THE CITY OF WALTHAM  
MASSACHUSETTS

**PURCHASE AND INSTALLATION OF INTERACTIVE PROJECTORS,  
WALTHAM SCHOOL DISTRICT**

**ADDENDUM NO. 1**

March 27, 2012

# PROJECTOR WALL PLATE INTERFACE

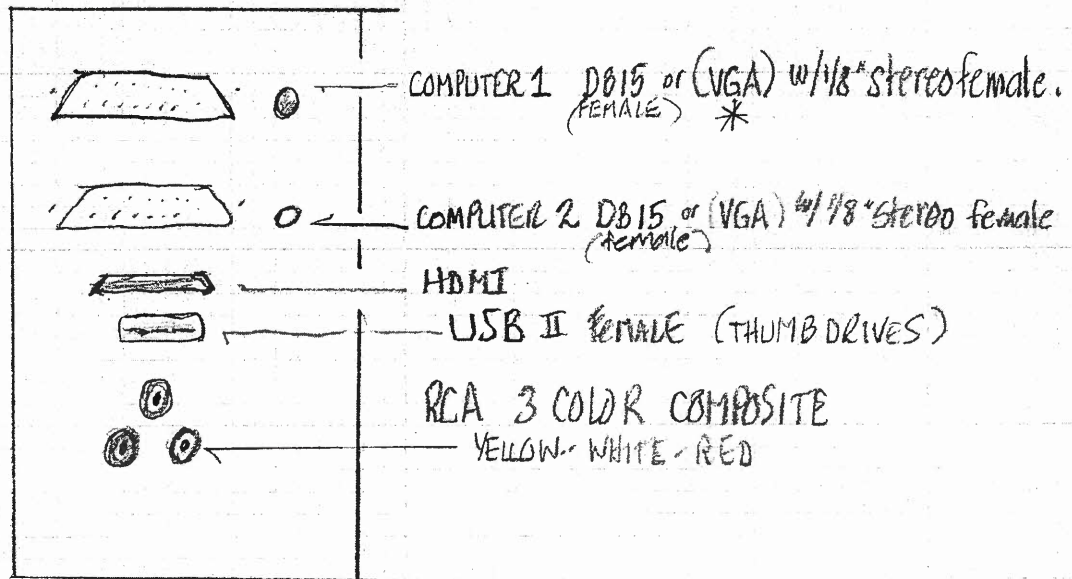
**Q3.** What types of connections are needed on the wall plate? VGA, HDMI, 3.5mm, USB (USB and VGA are a must in order to connect PC/ Laptop to projector)

**A3.** See attached Drawing.

\* DB15 FEMALE ACCEPTS SIGNAL FROM ALL  
VGA - SVGA - WXGA etc - PROJECTOR AUTO DETECTS  
RESOLUTION & INPUT CHANNEL.
